BAYOU TERREBONNE DRAINAGE PROJECT

PHASE I: BAYOU CANE PUMP STATION

TPCG PROJECT NO. 17-DRA-42

ADDENDUM NO. 1

TYPICAL STILL WELL DETAIL
 SCALE: 3/8"=1'-0"

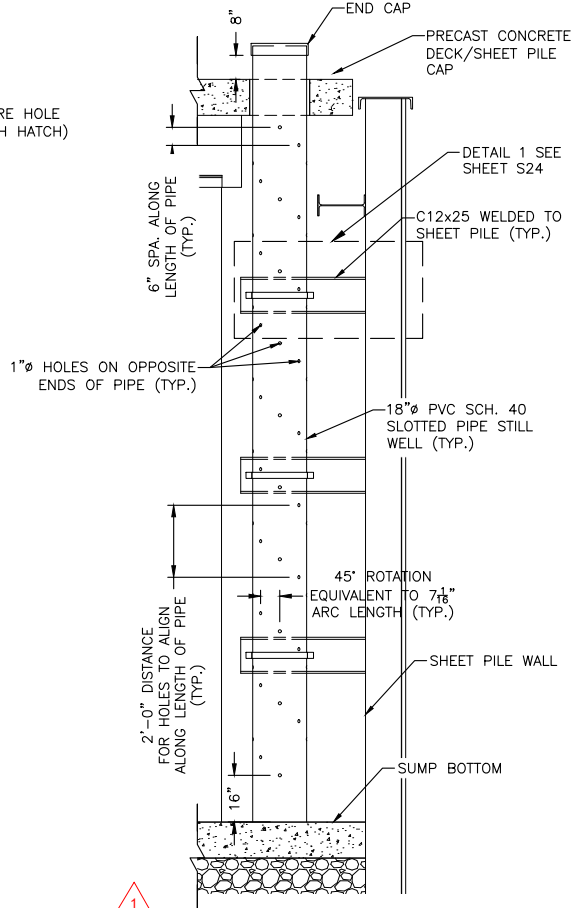
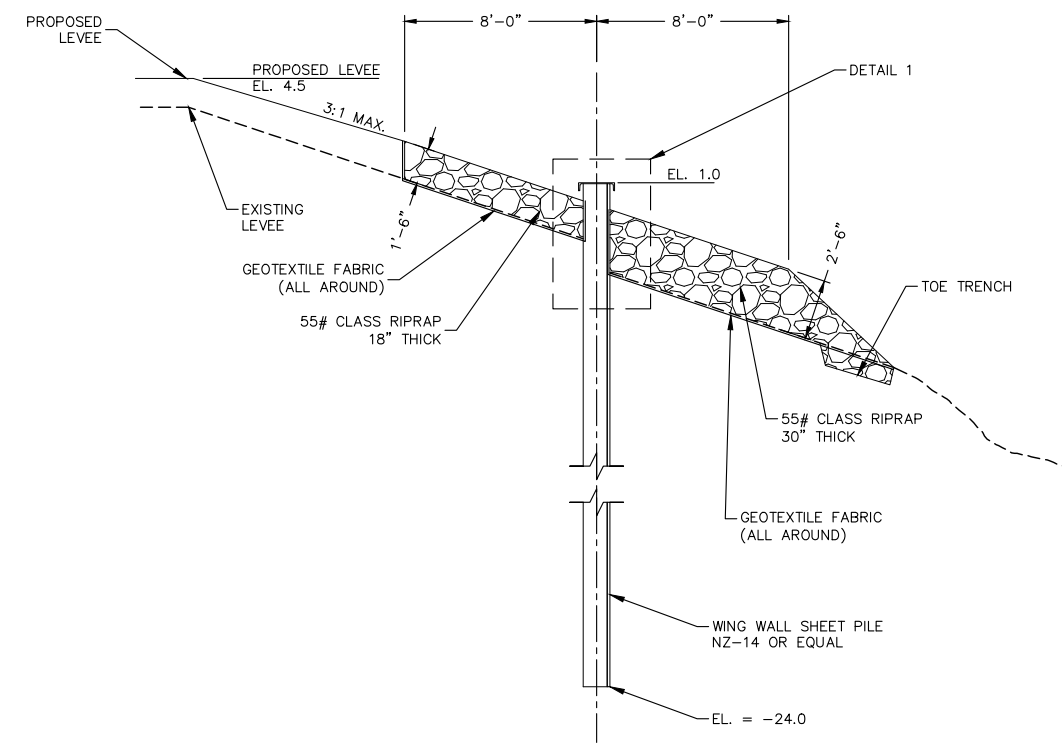
Response: Still well details have been added to the plans through this addendum. Refer to plan sheets C05, C07 & S24 for details.

3. *Plan Sheet C07 – TYPICAL SECTIONS & DETAILS* has been revised to include still well details. A revised plan sheet is attached to this addendum and shall govern and replace any previous versions.

STRUCTURAL SITE PLAN - EQUIPMENT SLAB

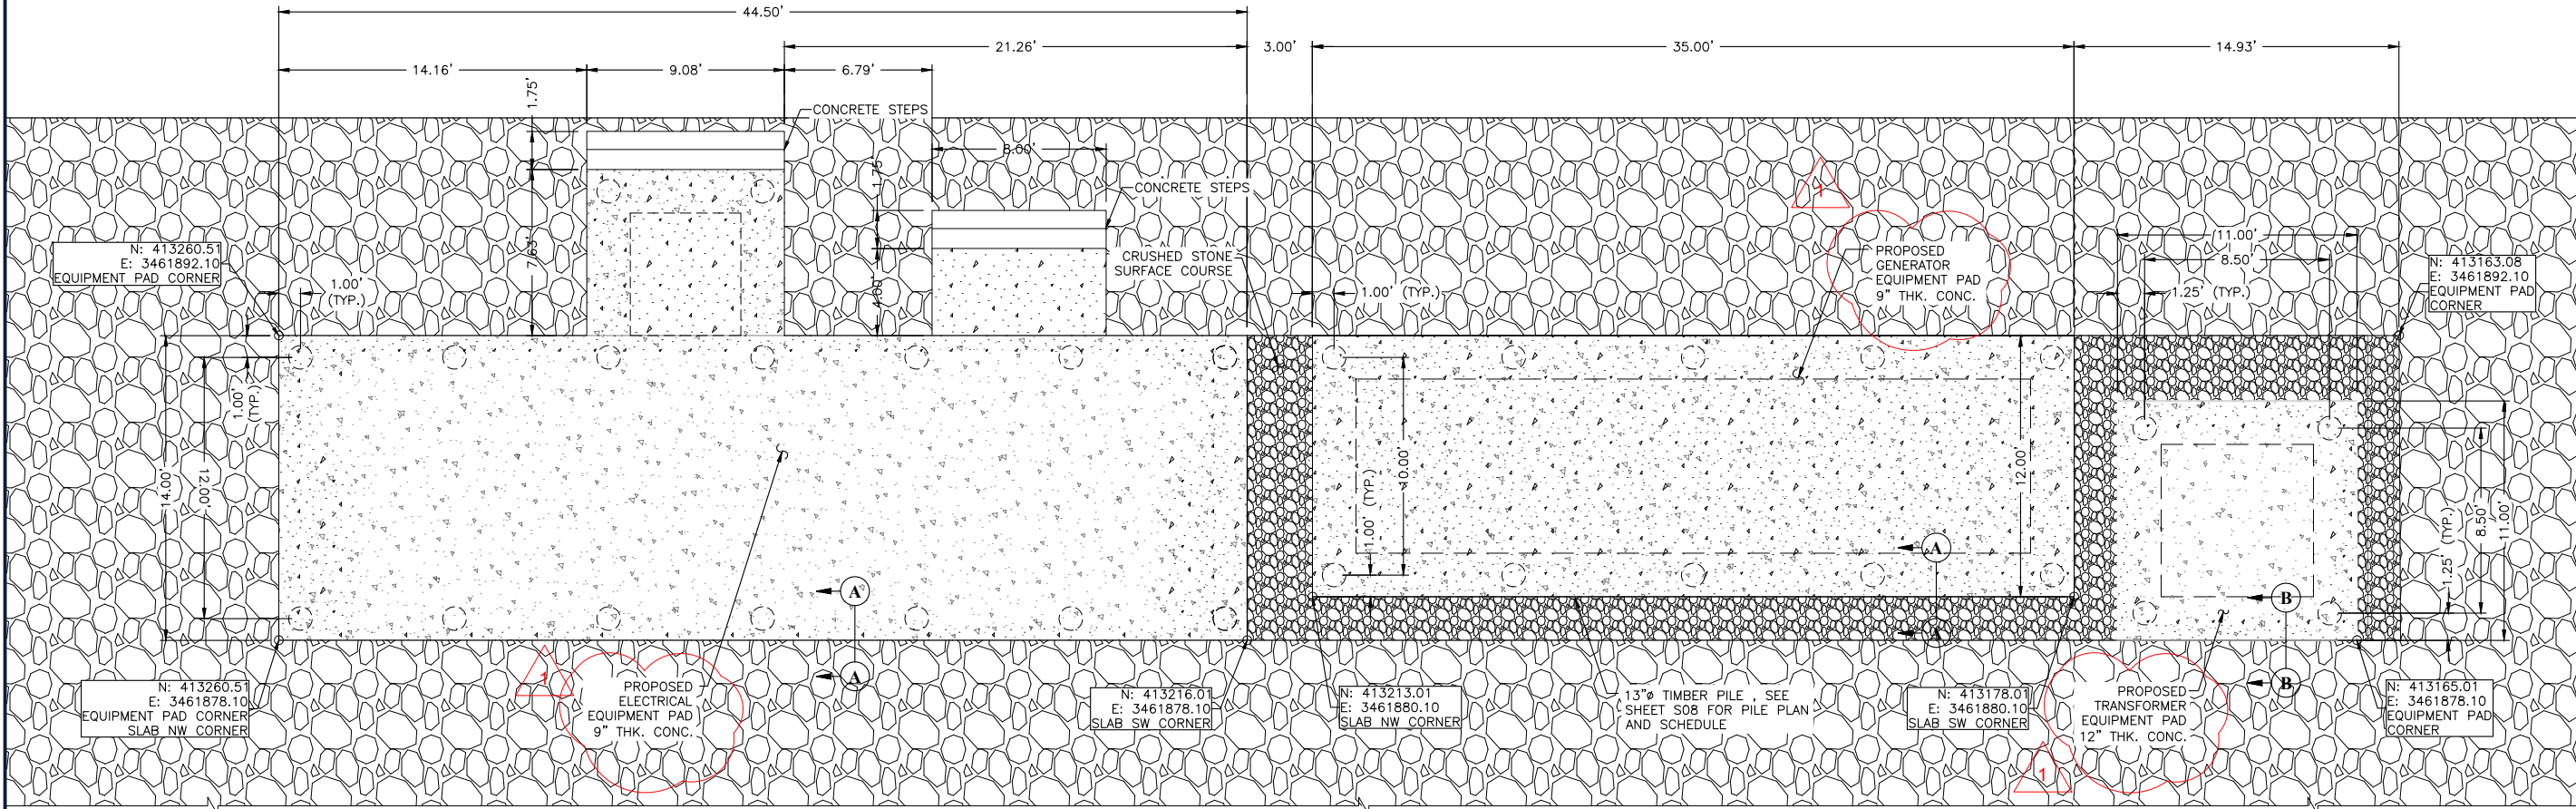
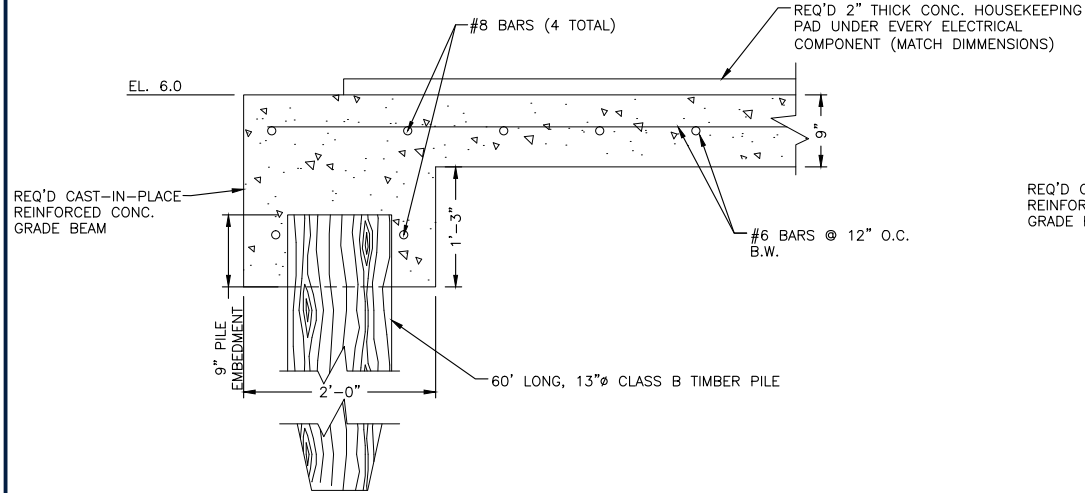
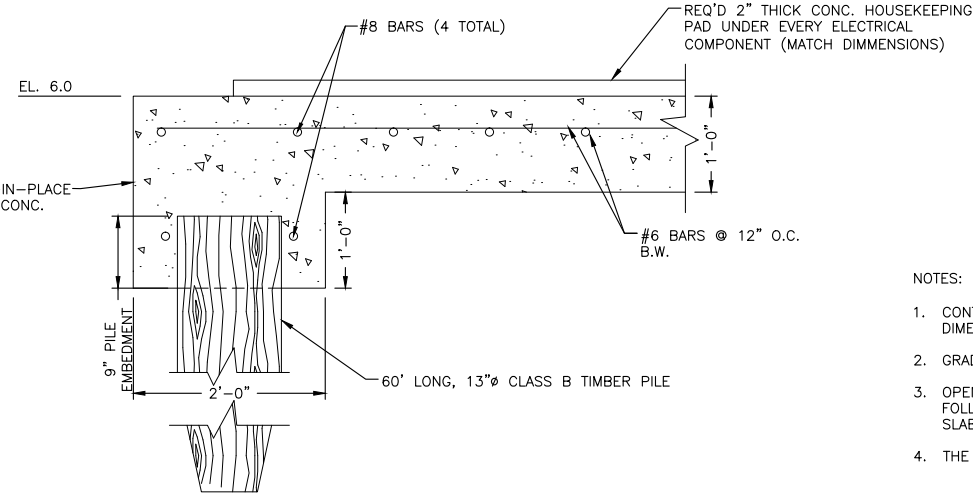
17. On sheet S03 it calls out for 9” slab on the equipment pad. On sheet S05 it calls out for 12”. Which is correct?

4. *Plan Sheet S03 – STRUCTURAL SITE PLAN – EQUIPMENT SLAB* has been revised for slab thicknesses. A revised plan sheet is attached to this addendum and shall govern and replace any previous versions.

Response: The concrete slab beneath the electrical building and beneath the generator shall be 9”. The concrete slab beneath the transformer slab (small slab) shall be 12”. Refer to the revised Plan Sheets S03 and S23 that is included in this Addendum.

PRECAST CONCRETE PANEL DECK PLAN
SCALE: 1/4" = 1'-0"

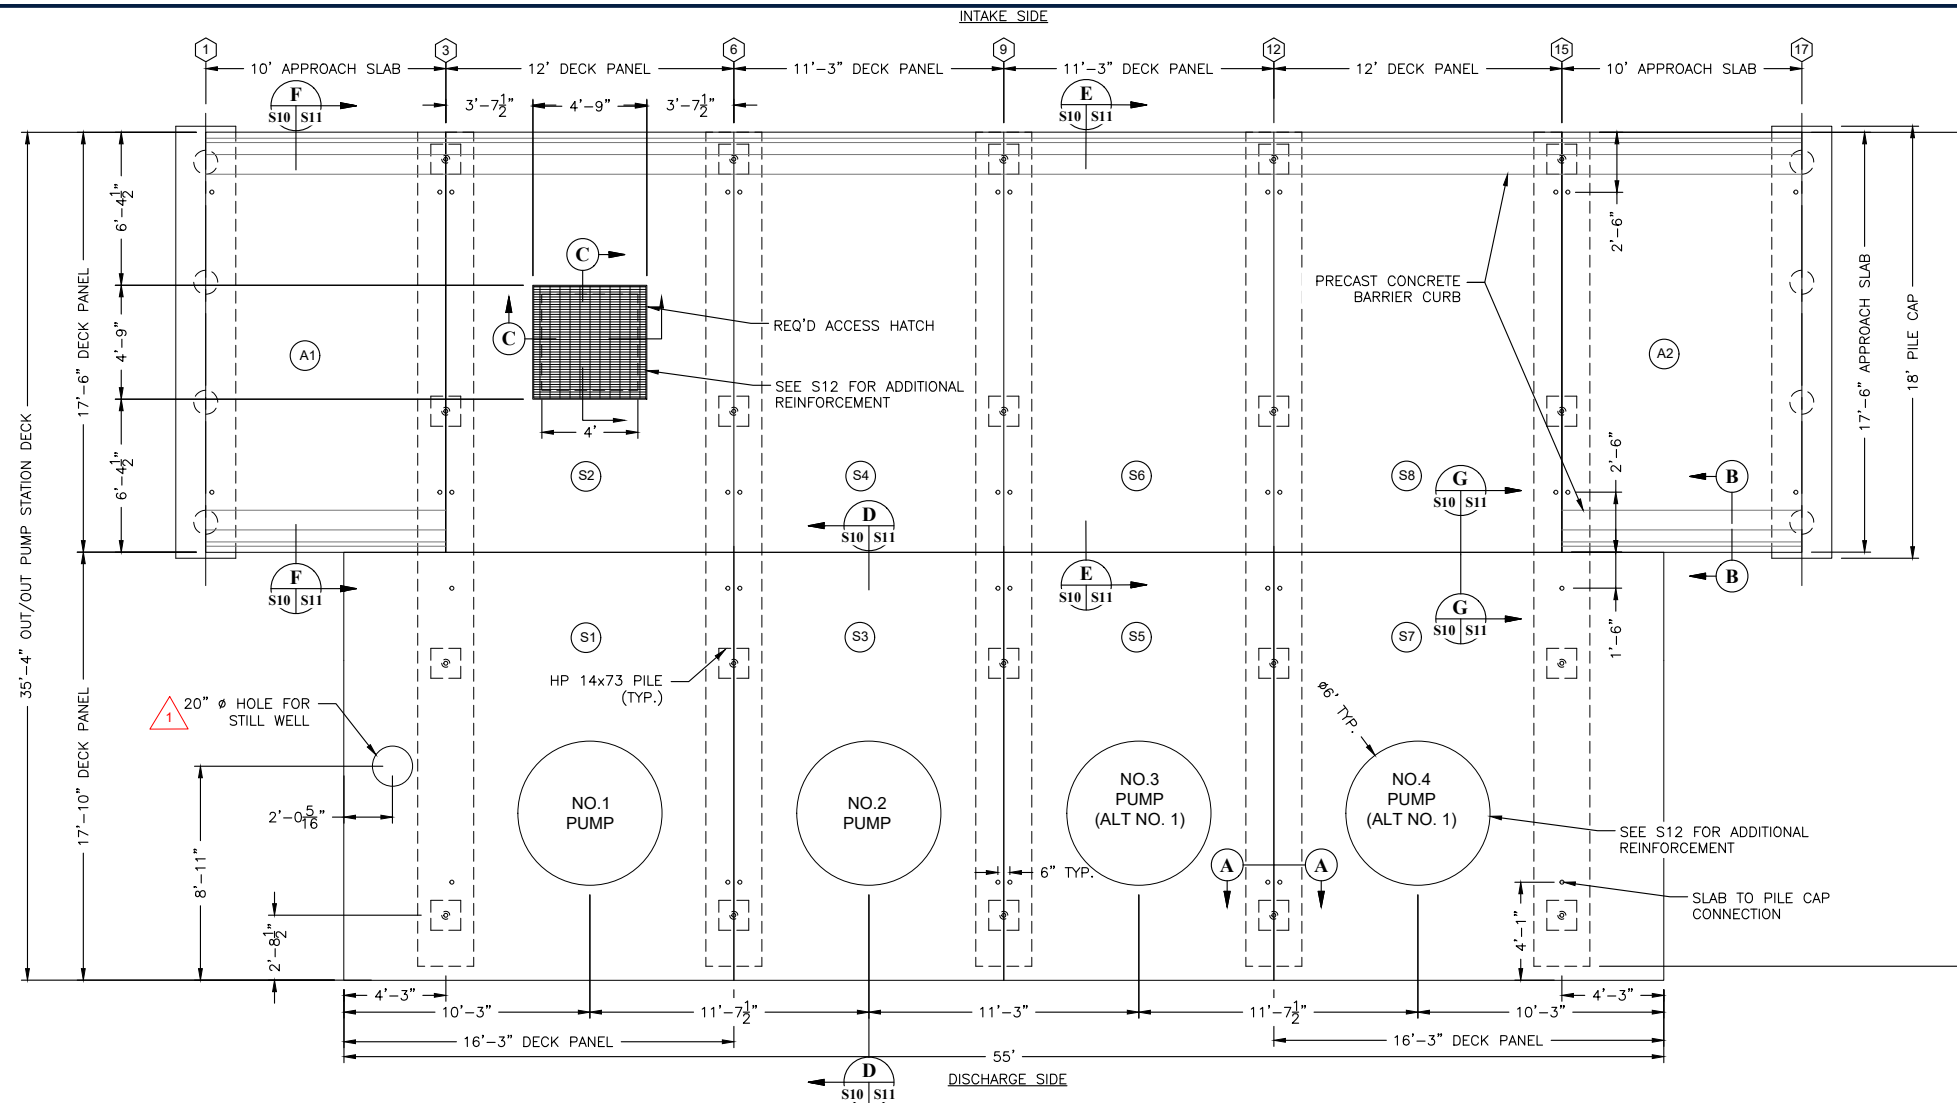
7. *Plan Sheet S10 – PRECAST CONCRETE PANEL DECK PLAN* has been revised to show proposed still well location. A revised plan sheet is attached to this addendum and shall govern and replace any previous versions.

Response: **Refer to Plan sheet S10 for grating detail.**

POWER SUPPLY BUILDING PLANS

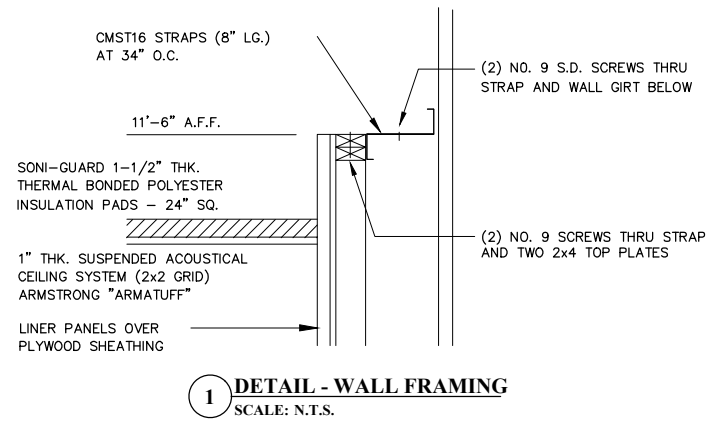
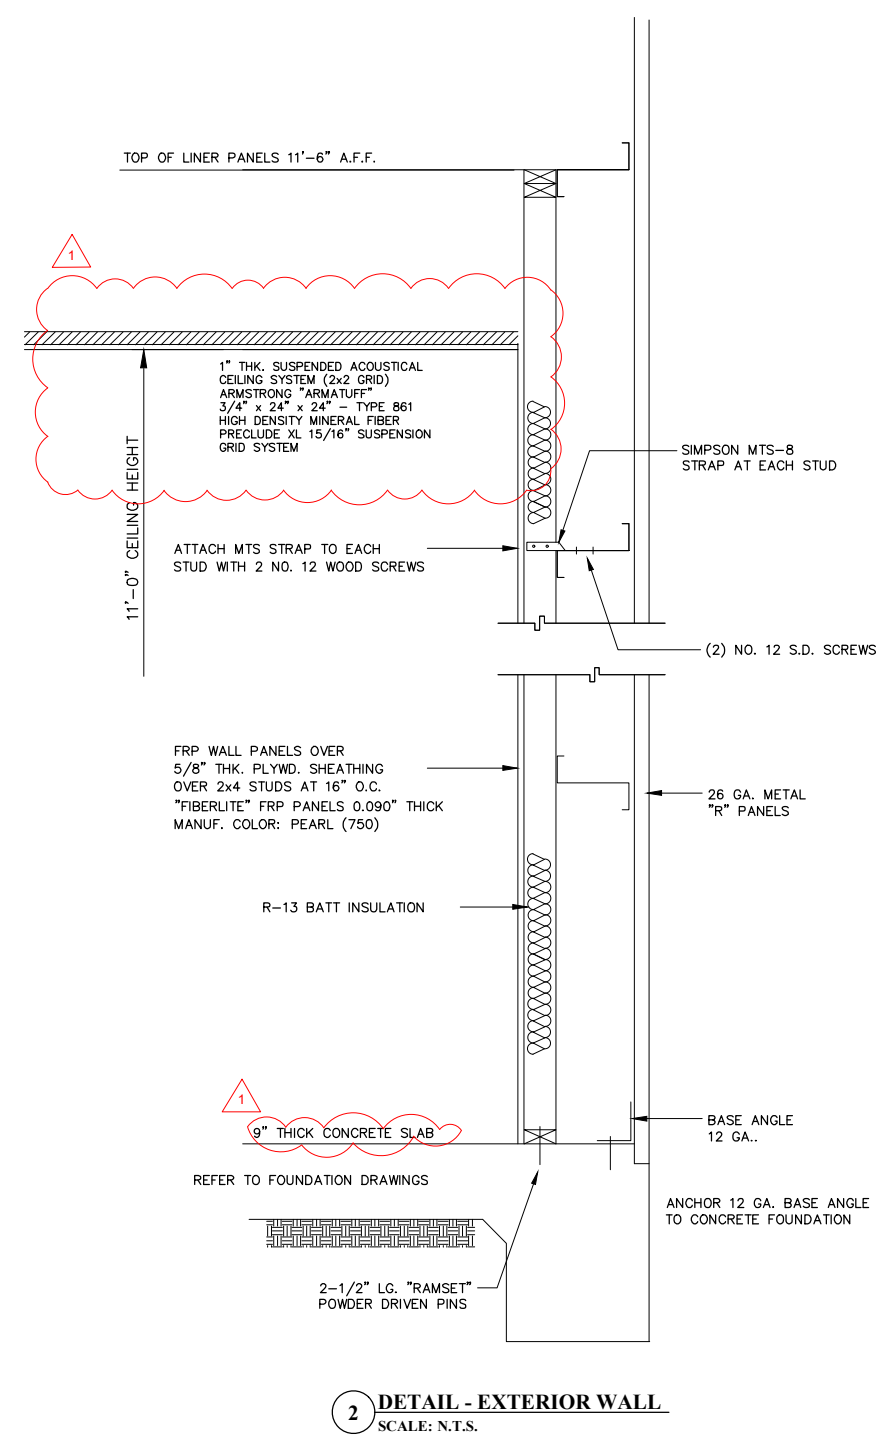
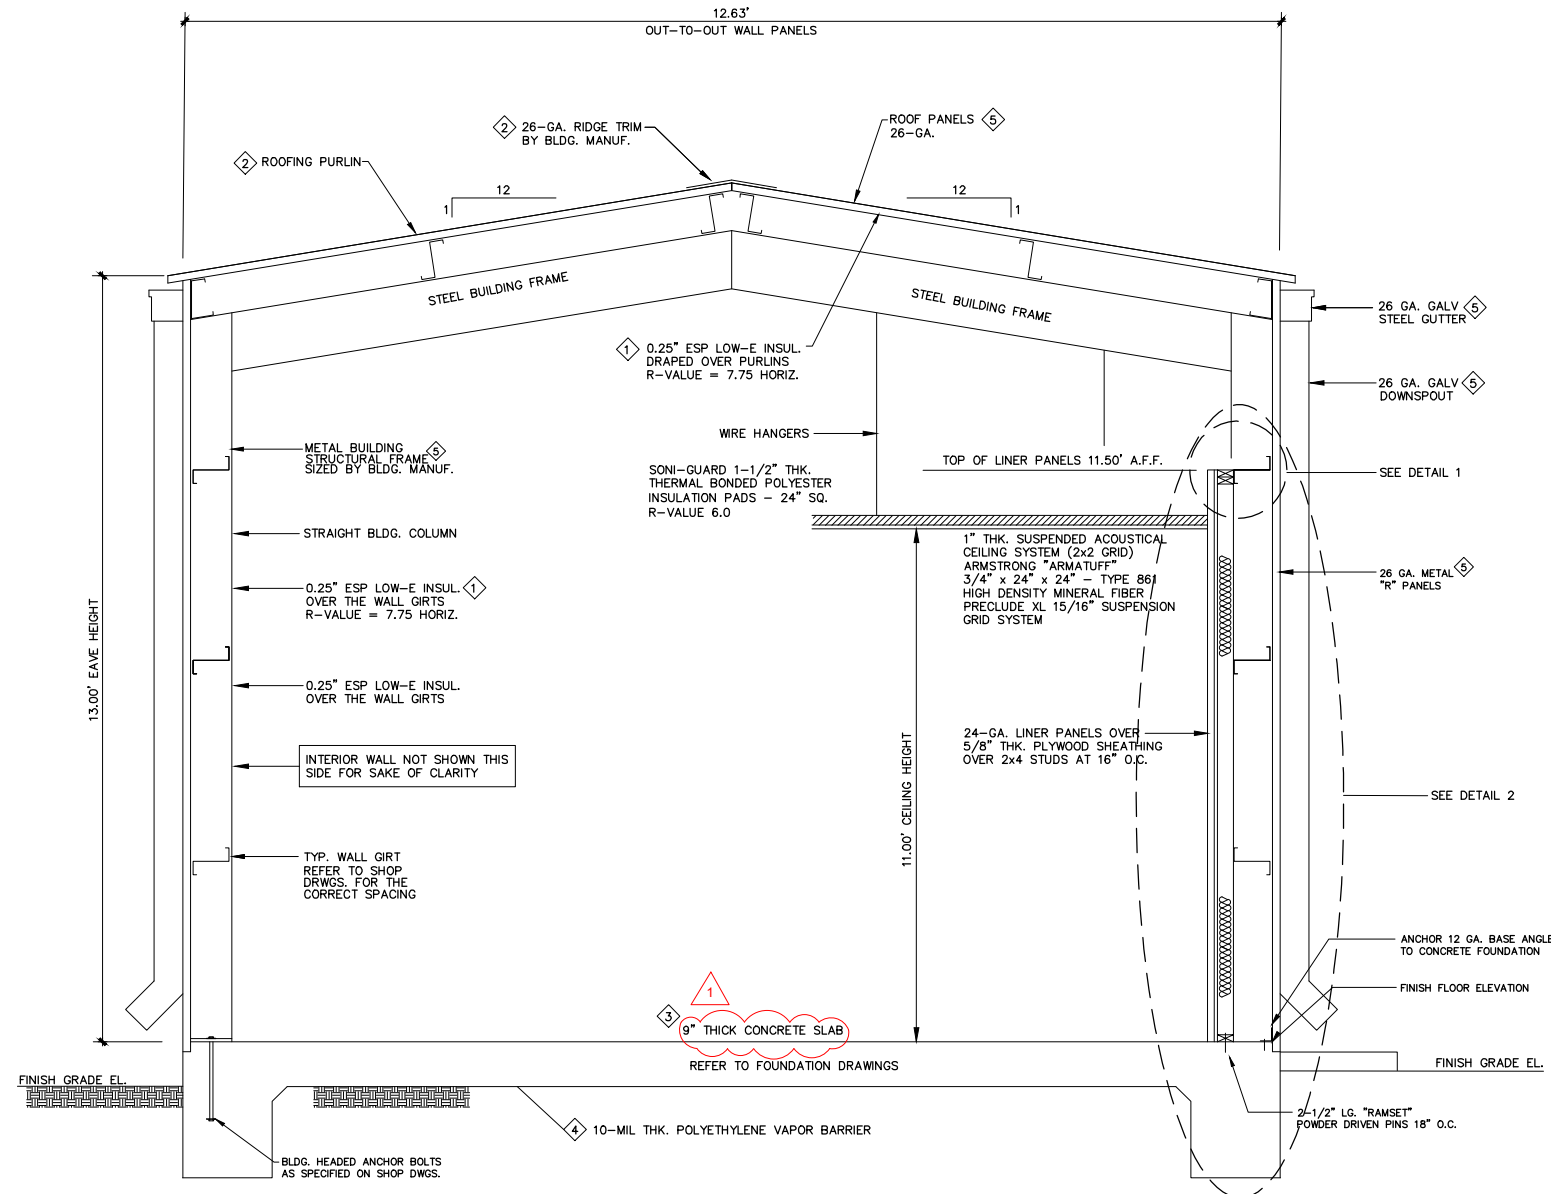
18. On sheet S05 which wall and ceiling detail do we use? A or B?

8. *Plan Sheet S23 – POWER SUPPLY BUILDING PLANS* has been revised to show slab thickness and ceiling detail. A revised plan sheet is attached to this addendum and shall govern and replace any previous versions.

Response: The wall and ceiling detail that should be used is detail 2. Refer to the revised Plan Sheet S23 that is included in this Addendum.
